EVGSAU 3333-002W (API 30-025-02982) MIT REMEDIATION – RTI

OBJECTIVE: Well Failed MIT. Will perform necessary investigative steps to determine cause of leak, and will remediate as necessary based on findings. Ultimate goal is to RTI.

Action 505186

Operator:	OGRID:
Maverick Permian LLC	331199
1000 Main Street, Suite 2900	Action Number:
Houston, TX 77002	505186
	Action Type:
	[C-103] NOI Workover (C-103G)

Current WBD below: Expand Image if needed, or refer to WellView for full WBD Detail

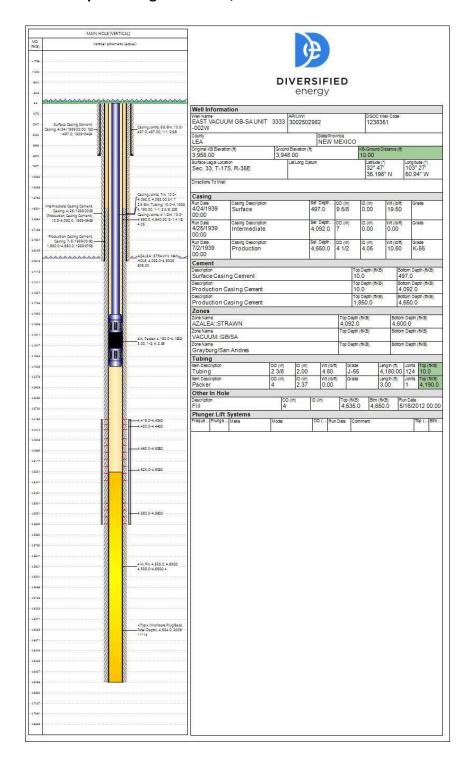
Created By		Condition Date
anthony.harris	Post workover MIT required with OCD witness Same size tubing to be installed (no upsize permitted) As per WFX-653, Packer should be set within 100 ft of top perforation. Submit post workover C-103 Subsequent report with an updated wellbore diagram	9/26/2025
